**Department of Energy**  
Carlsbad Field Office  
P. O. Box 3090  
Carlsbad, New Mexico 88221

**Subject: Response to EPA May 20, 2004 Letter on CRA**

In response to the Environmental Protection Agency's (EPA's) letter of May 20, 2004, and the request for information received during the EPA Run Control Inspection the Week of August 9, 2004, the U.S. Department of Energy (DOE) is providing information to answer the questions included in the enclosure to that letter and answer the inspection information request.

Figure 1. Comparison of SANTOS and SPECTROM-32 Results for Three Different Gas Generation Rates.

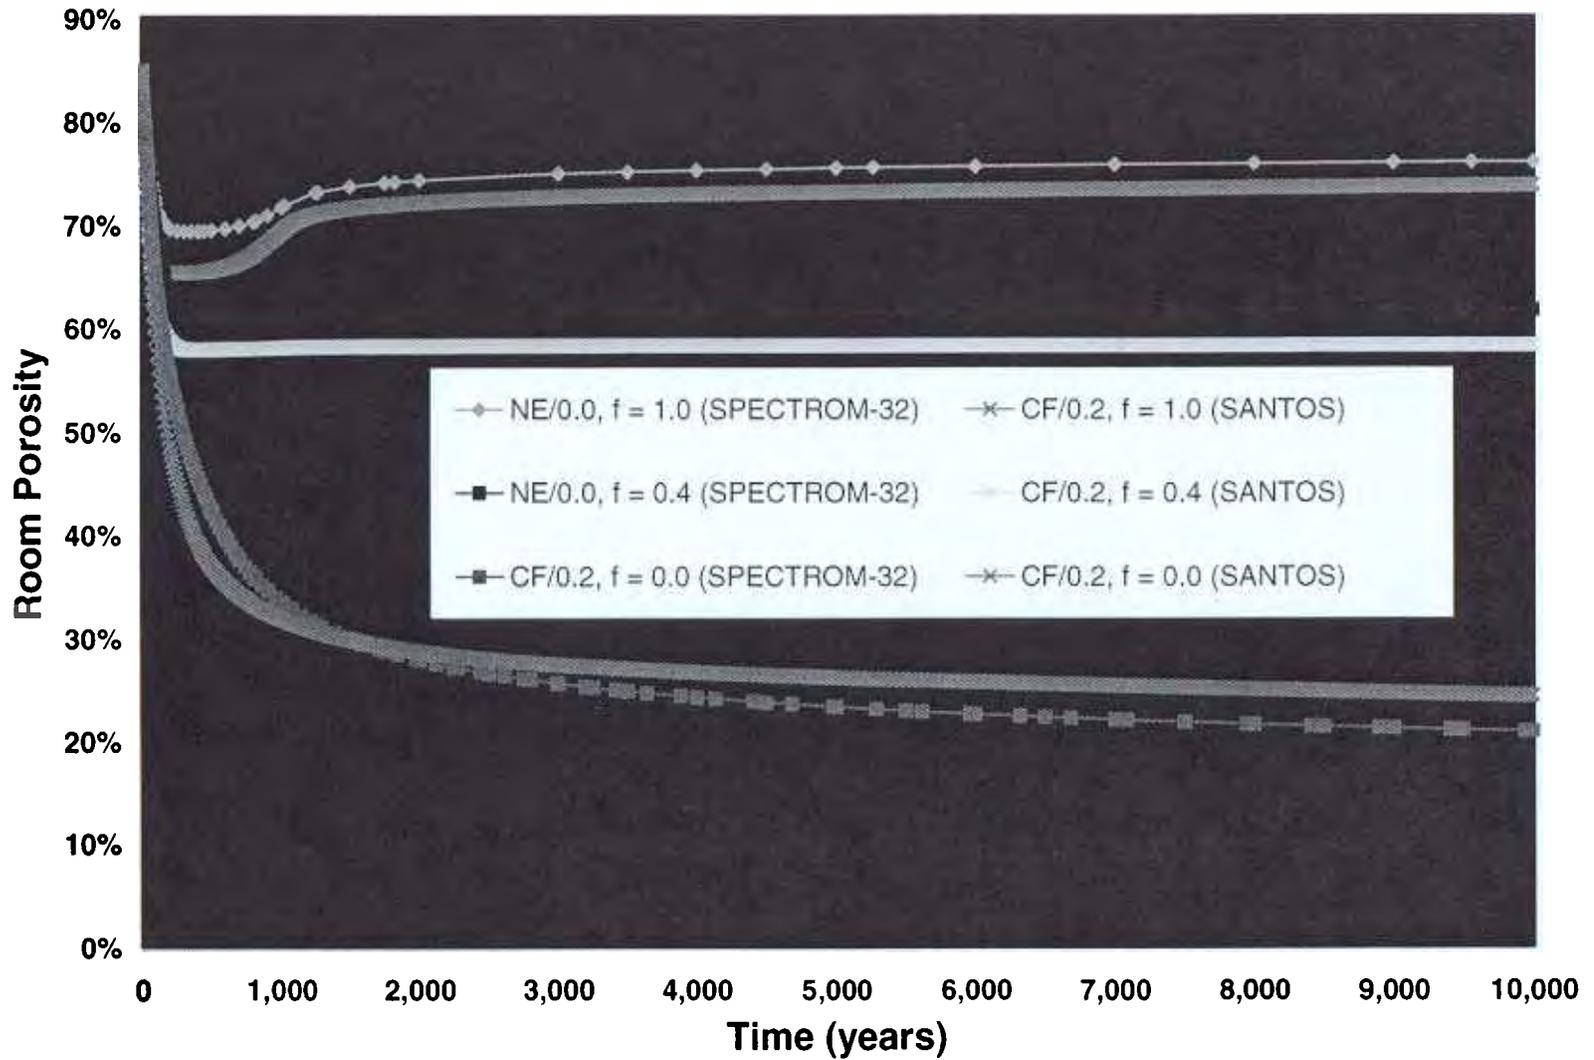
*"After completing the Agency's review, the EPA has concluded that 36 (of the 39) computer codes and three libraries migrated to the Compaq ES45 and 8400 with OpenVMS 7.3-1 are approved for use in compliance calculations for the WIPP performance assessment. Final technical review of the remaining three codes (e.g., NUMBERS, SANTOS, DRSPALL) will be conducted separately as part of the Agency's review and evaluation of the CRA. Specifically, the EPA will ensure that:*

- 1. DRSPALL, 1.0 is regression tested on the Compaq ES45 and 8400;*
- 2. NUMBERS meets the QAP 19-1 requirements; and*
- 3. SANTOS is properly evaluated for accuracy."*

Figure 1 compares room porosity results obtained with SPECTROM-32 and SANTOS for gas generation rates ( $f$ ) of 0, 0.4, and 1. For the case with no gas generation, the SPECTROM-32 porosity results are slightly higher than the SANTOS results earlier in time and slightly lower than the SANTOS results later in time. At 10,000 years, the SPECTROM-32 and SANTOS results differ by about 3.4% room porosity (i.e., 20.9% versus 24.3%). For the gas generation cases ( $f = 0.4$  and  $f = 1.0$ ), the SPECTROM-32 results were computed using a nonlinear elastic model for the TRU waste with a Poisson's ratio of zero; whereas, the SANTOS results were generated using the crushable foam model for the TRU waste with a Poisson's ratio of 0.2. Despite these TRU waste model differences, the SPECTROM-32 and SANTOS room porosity results are quite similar with the SPECTROM-32 results being consistently higher than the SANTOS results. At 10,000 years, the SPECTROM-32 ( $f = 0.4$  case) result is about 3.4% room porosity higher than the SANTOS result (i.e., 61.7% versus 58.3%). At 10,000 years, the SPECTROM-32 ( $f = 1.0$  case) result is about 2.2% room porosity higher than the SANTOS result (i.e., 76.0% versus 73.8%).

Improvement to the TRU waste model can be obtained with the nonlinear elastic model by elimination of the out-of-plane tensile stresses; however, the global response of the waste will not be affected significantly. The uncertainty in the constitutive model for the waste is minor and inconsequential in cases involving moderate gas generation because the presence of the waste is not important when the room is supported by the generated gas pressures. These results show that the TRU waste constitutive model becomes less important with gas generation. In other words, as the magnitude of the deformation in the TRU waste decreases because of gas generation, the mechanical behavior of the waste and its interaction with the underground structure becomes less important.

**Figure 3. Sensitivity of Spallings Releases to Assumptions About Container-Scale Variability**

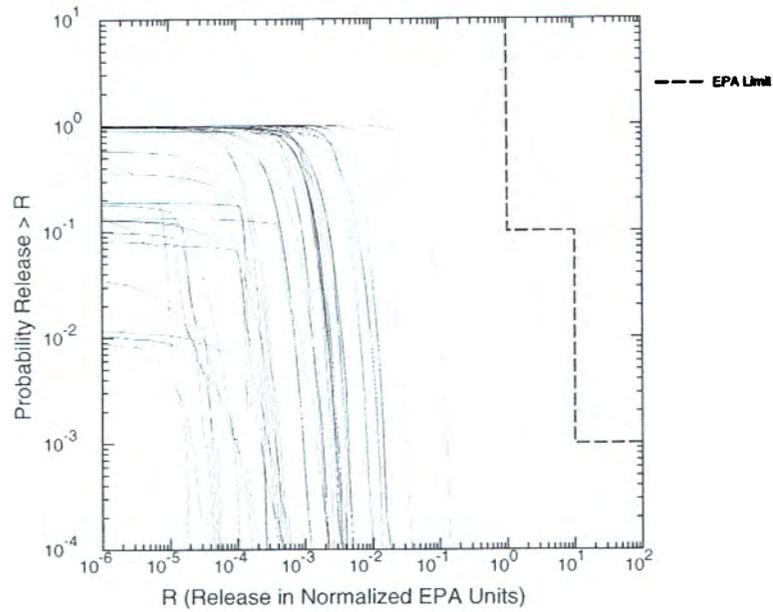
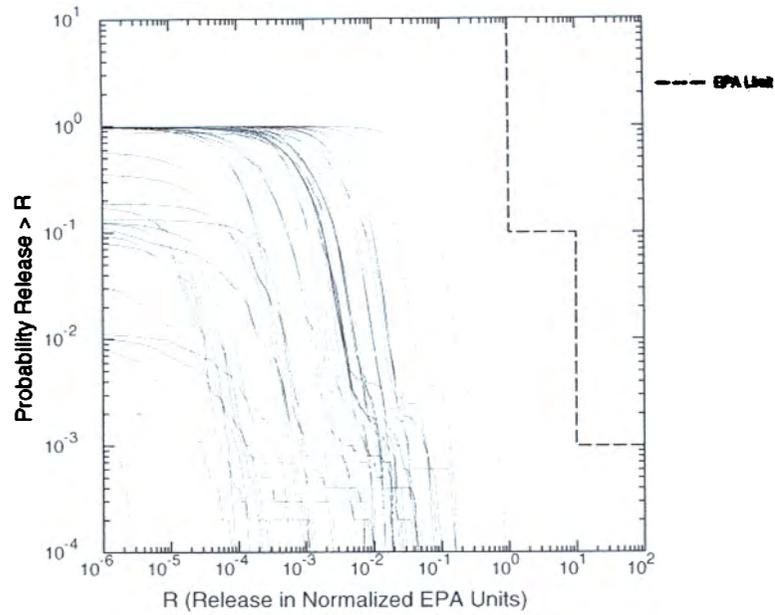
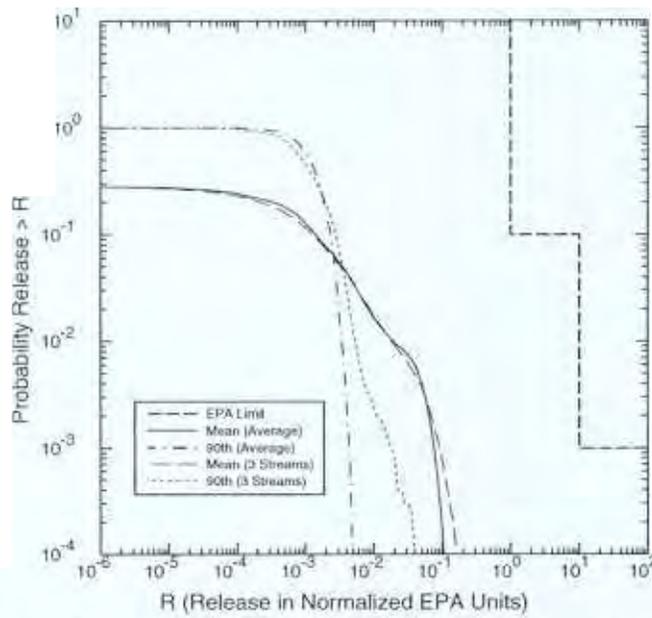
*The CRA states that “spallings are assumed to be derived from a sufficiently large volume of waste that container-scale variability can be neglected.” While we accepted this assumption in the original certification decision, since then DOE has used a number of different container configurations-such as ten drum overpacks and supercompacted waste-with greater frequency than estimated earlier. In addition, the new DRSPALL code generally predicts much lower release volumes. For these reasons, neglecting container-scale variability may not be a valid assumption.*

*DOE must fully justify the existing waste spall model given the changes in waste container since the CCA and the new spallings model results or must rerun the CRA PA with assumptions that better reflect the container variation.*

Figure 1 shows the 100 complementary cumulative distribution functions (CCDFs) for CRA Replicate 1 spallings releases that were computed using the average radioactivity across all CH waste streams. Fifty-eight of the 100 vectors fall off-scale with values too low to plot. Figure 2 shows the 100 CCDFs for CRA Replicate 1 spallings releases that were computed using the randomly sampled waste streams. Fifty-seven of the 100 vectors fall off-scale.

Figure 3 shows the mean and 90<sup>th</sup> percentile curves for both the spallings releases calculated using the average radioactivity of all the waste streams and the spallings releases calculated using the radioactivity of the randomly selected waste streams. The two mean CCDFs are nearly identical everywhere except at very low probabilities. The 90<sup>th</sup> percentile curve calculated using the randomly selected waste streams shows higher releases than the 90<sup>th</sup> percentile curve calculated using the total average radioactivity, but the largest deviations occur at low probabilities. It is not surprising that the 90<sup>th</sup> percentile curves differ somewhat because the second method of computing spallings releases introduces greater variability. Thus, we expect the 90<sup>th</sup> percentile curve for the random sampling method to show higher releases than the 90<sup>th</sup> percentile curve for the average radioactivity method shows.

Therefore, this analysis concludes that calculation of spillings releases is not significantly affected by waste-scale variability.
